U.S. Department
of Transportation
**Federal Highway
Administration**

December 21, 2004

In Reply Refer To: HSA-10/CC-64E

In your November 29 letter, sent to Mr. Richard Powers' attention, you requested the Federal Highway Administration's (FHWA) acceptance of a modified design of your previously accepted 229-cm (90-inch) long test level 2 (TL-2) U-MAD 70K truck mounted attenuator (TMA). Specifically, you requested acceptance of a shorter unit (198-cm or 78-inches long) at the same test level.

U-MAD 70k tested at 70k
 Proposed 78" Cushion
 Copyright U-MAD 70k

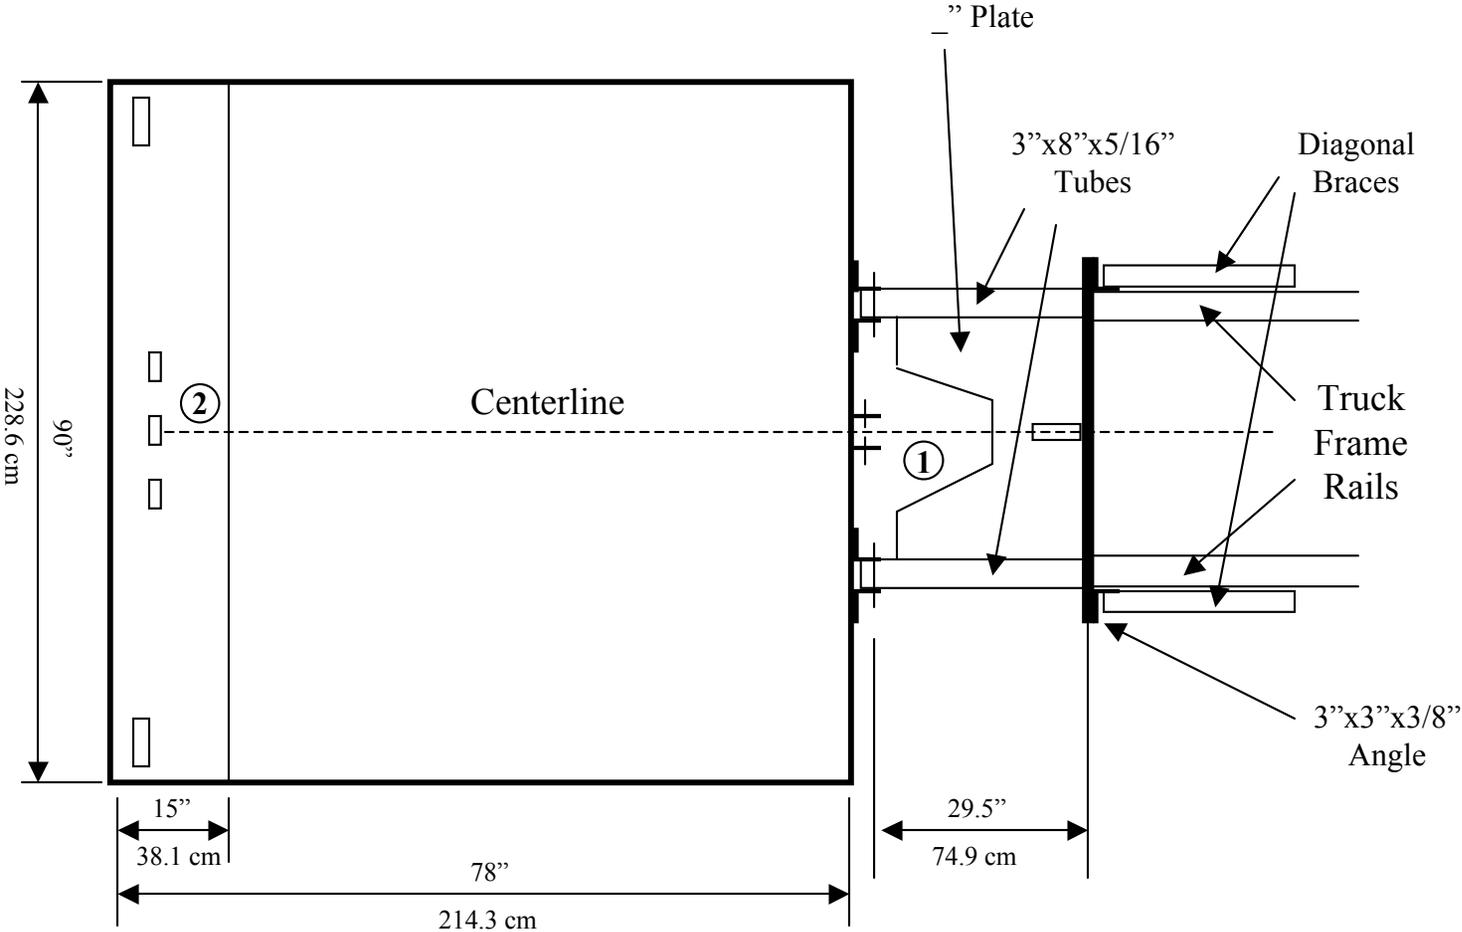
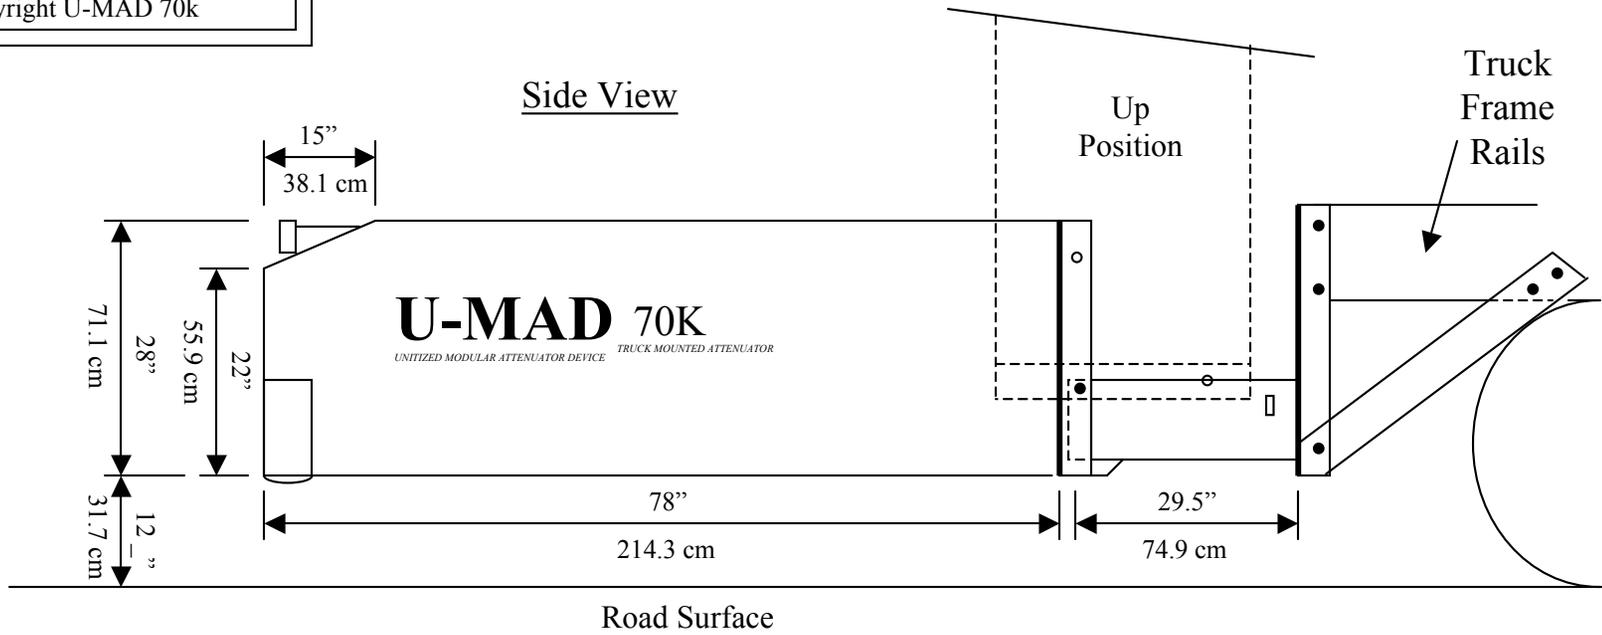
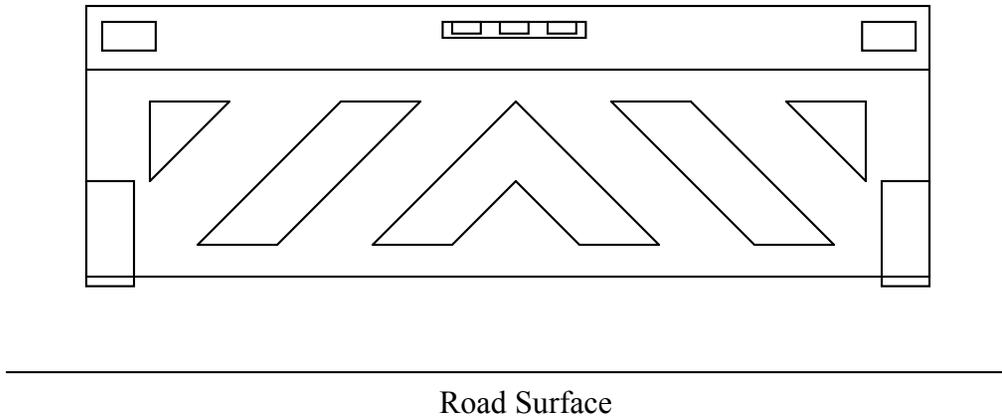
To support your request, you stated that your earlier 70-km/h test with an 820-kg car (into the longer U-MAD 100K unit) resulted in a TMA penetration of approximately 150 cm (60 inches) and concluded that a 183-cm (72-inch) long unit with the same density in the crushed area would meet TL-2 evaluation criteria with the small car. You then ran the TL-2 pickup truck test 2-51 into a 183-cm (72-inch) long unit. The results of this test were contained in the Transportation Research Center's December 2003 - January 2004 report entitled "NCHRP Report 350 Test 2-51 of the U-MAD 70K Truck Mounted Attenuator". The truck impacted the TMA at 67.4 km/h. Occupant impact velocity was reported to be 9.4 m/sec and the ridedown acceleration was 16.5 g's. The 8595.6 kg support vehicle rolled ahead 3.9 meters. However, the test report noted that the "total crush of the TMA was not recorded due to the impacting vehicle's ... crushing the TMA and ultimately bending and breaking the cushion's lift plate".

Although meeting Report 350 evaluation criteria, testing revealed that a 183-cm (72-inch) long U-MAD 70K TMA had essentially no reserve capacity and its mounting hardware was damaged in the crash. Consequently, you requested the FHWA acceptance of a 198-cm (78-inch) long unit at TL-2. I agree that the 198-cm (78-inch) long U-MAD shown in the enclosure to this letter may be assumed to meet Report 350 evaluation criteria for a TL-2 TMA and may be used on the National Highway System (NHS) when such use is deemed appropriate by the contracting authority.
